RE: **Wildflower Cottages at Haymeadow**
Drainage Conformance Letter
HKS Project No. 2504026

WILDFLOWER COTTAGES AT HAYMEADOW
PROPOSED DRAINAGE PLAN

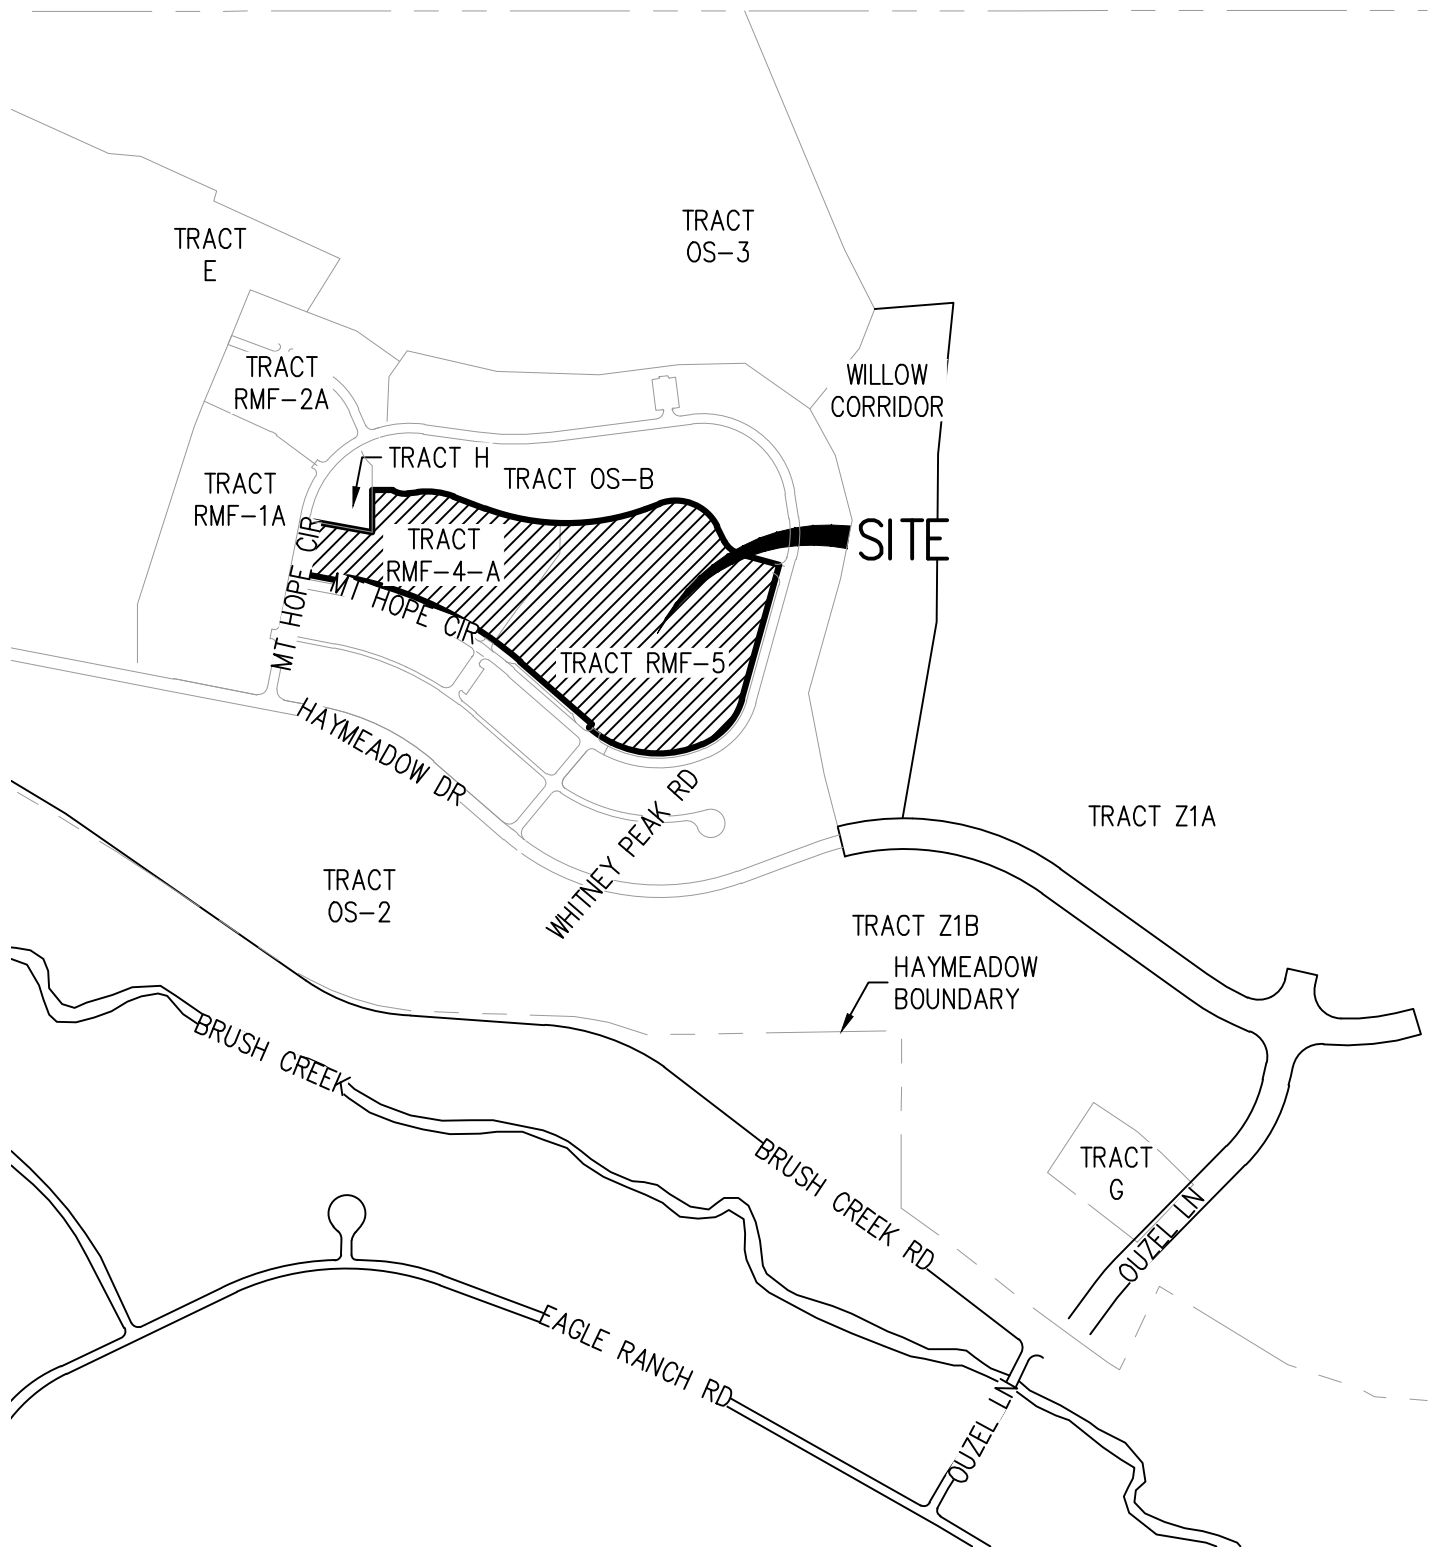
letter should be stamped

HKS - Stamp added to letter.
